## STATEMENT OF WORK (SOW)

### ANG OSP INSTALLATION

ITB 935 to 917, 930, 933, 937, 946, 956, 957, 962, 968, 969, 970, 1143, 1147, 1151, 1155

| Revision History as of 19 August 2026, REV 1 |                                                                 |                                  |

### 8.1 Figure 1: FOC Route from ITB 935 to EB 933

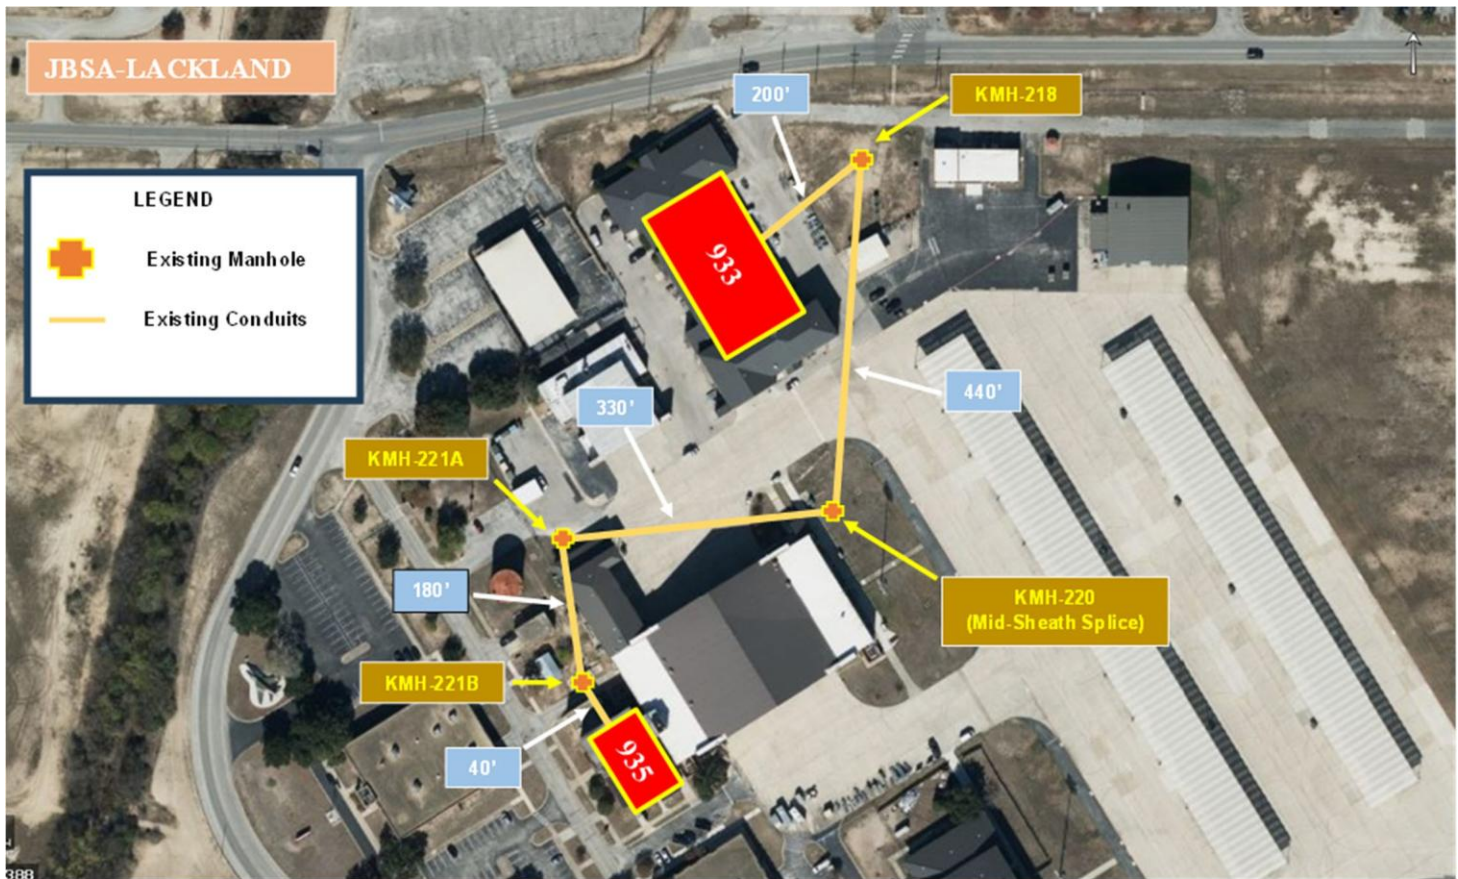
The Contractor shall install approximately 1090 feet of 36-strand SM ~~armor-shielded~~ **dielectric, loose tube** FOC from ITB 935 through KMH-221B, KMH-221A, and KMH-220 to KMH-218. See Figure 1.

The Contractor shall install approximately 250 feet of 12-strand SM ~~armor-shielded~~ **dielectric, loose tube** FOC from KMH-218 to EB 933. Splice the 12-strand SM ~~armor-shielded~~ **dielectric, loose tube** FOC to the 36-strand SM ~~armor-shielded~~ **dielectric, loose tube** FOC coming from ITB 935 in KMH-218. See Figure 1.

8.13 Figure 13: FOC Route from ITB 935 to EB 1143, 1147, 1151 and 1155 (2 of 2)

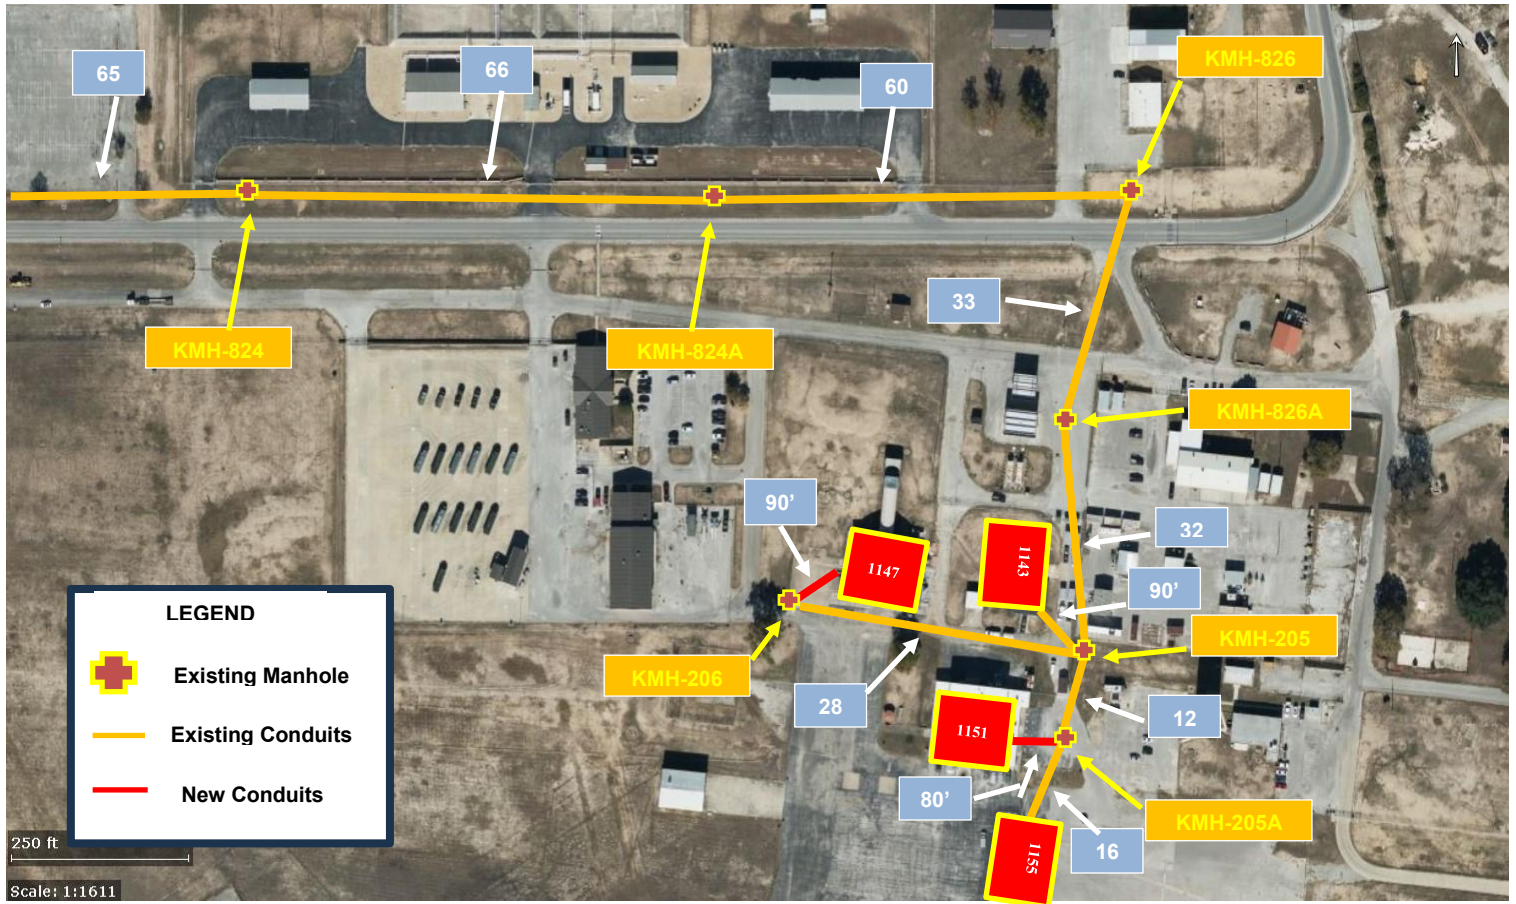
| Revision History as of 19 August 2026, REV 1 |                                                                 |                                  |
|----------------------------------------------|-----------------------------------------------------------------|----------------------------------|
| Figure 13                                    | FOC Route from ITB 935 to EB 1143, 1147, 1151 and 1155 (2 of 2) | Updated Figure                   |
